Accessibility Survey

City of Downey Pico Vista Road - End to Cul-De-Sac

Date of Inspection
6/9/2017

Prepared By
Disability Access Consultants
(800) 743-7067

Top Landing

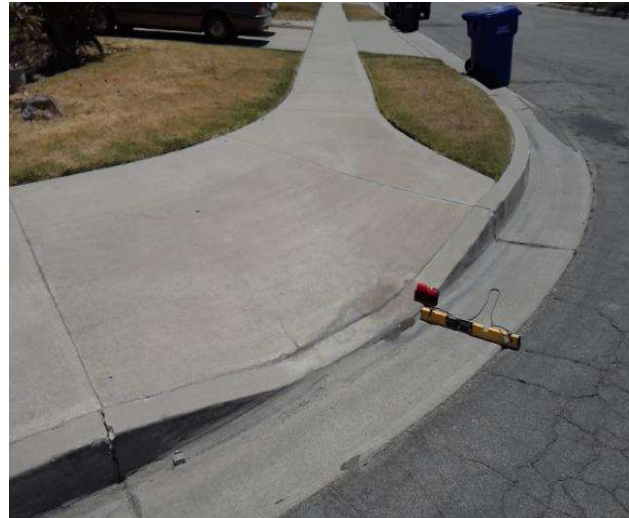
The slope at the top landing is greater than allowed.

On-Site Finding 3.00 percent

Provide a top landing surface that does not exceed the maximum slope and cross slope. Provide a sufficient maneuvering clearance that does not accumulate water.

Recommendation Up to 2.08 percent

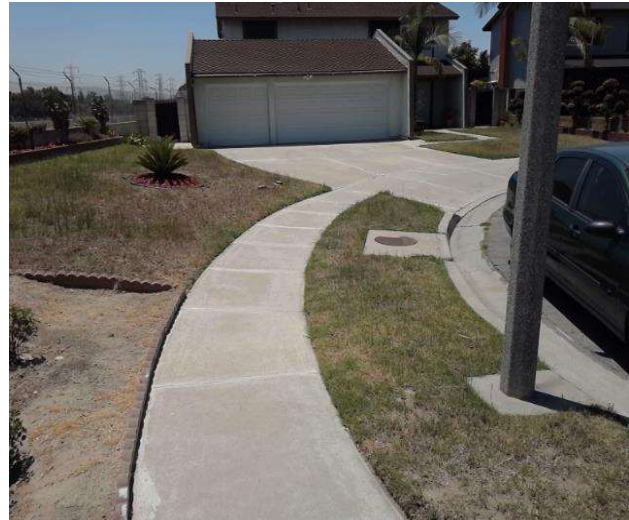
Sidewalk cross slope is not compliant.

On-Site Finding 6.10 percent for 152.00 feet

Repave the sidewalk surface with the recommended cross slope.
